**Draft Specifications on the
Application of the UNFC-2009 to
Renewable Energy**

Response to public and TAG comments

EGRC, 6th session, 30 April 2015

Public comments

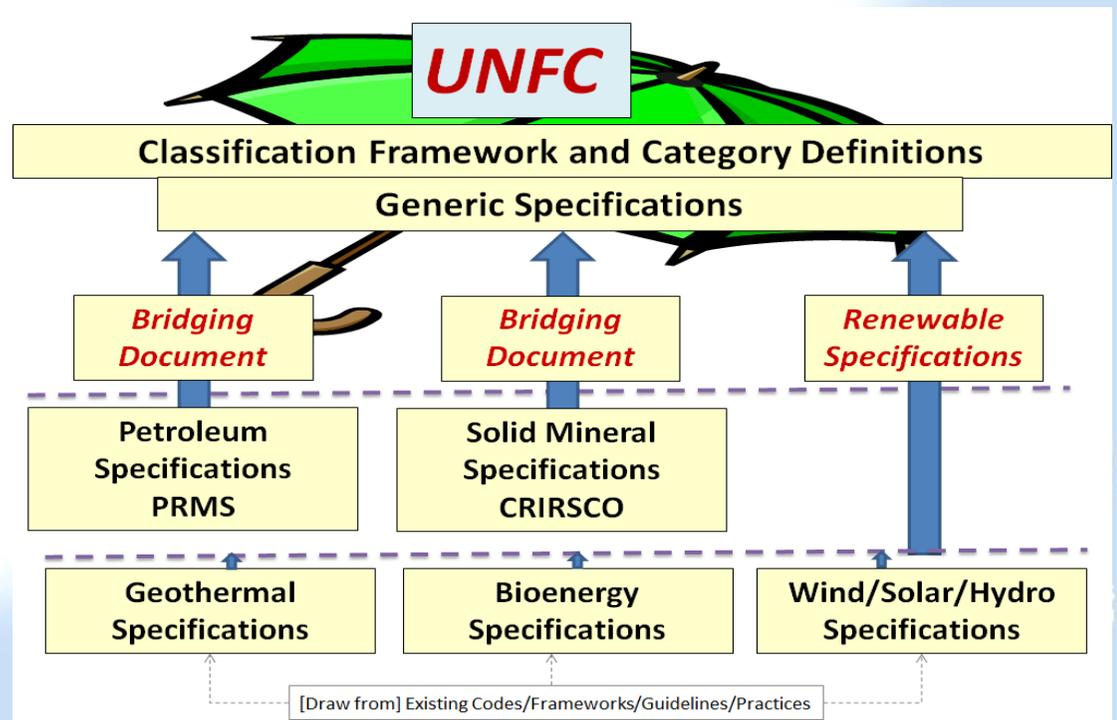
A total of 59 comments have been made by 15 individuals

The Task Force has the following high-level observations from these comments:

- There is general support that the UNFC-2009 can be applied to Renewables.
- Some comments appear to have been made on the basis of the Renewable Specifications in isolation, without appreciation that these are meant to complement and be consistent with the UNFC-2009.
- There is some confusion about “Annual Capacities” and “Potentials” versus the project-based concept of the UNFC-2009, which is a key aspect to continue to clarify in stakeholder engagement events and commodity-specific specifications.
- There is some misunderstanding between the role of the G axis vs. that of the F and E axes (additional and improved training material may be required?)
